Change of Main Board. All 321 and 391 models

SUBJECT: Main board is supplied from vsel Electronic

ITEM NR: ECN124E / 04-03/FR10 E

PURPOSE: Alternative supplier

Component picture

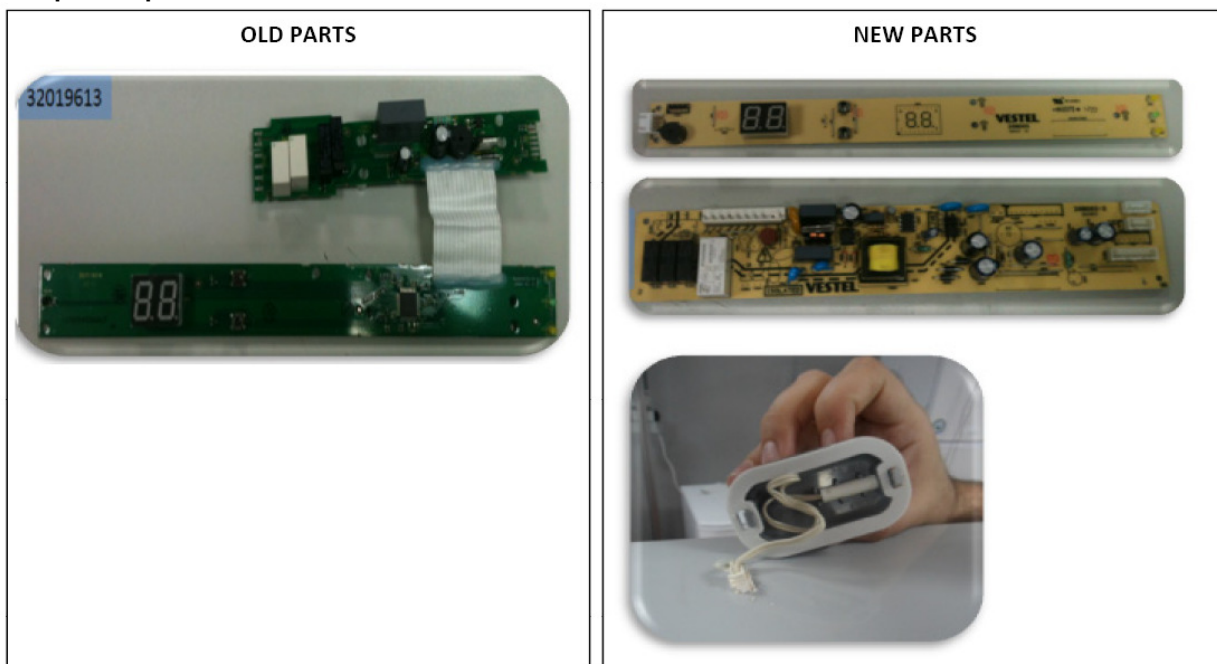
OLD PART		NEW PARTS:	
4055213153	MAIN BOARD/391-321	4055254868	MAIN BOARD/VE(BDA02-3)391
-		4055254934	DISPLAY CARD/VE(20BDD03)391
-		50298477006	SENSOR
-		4055143780	HOLDER-SENSOR (WHITE)
-		4055182812	HOLDER-SENSOR (GRAY)

AT (Ambient Temperature) sensor was moved to top of the appliance.

Appliance's height increased 13mm. Sensor cover and ambient sensor were added.

If the unit was produced before 26.02.2013, 4055213153 code must be used.
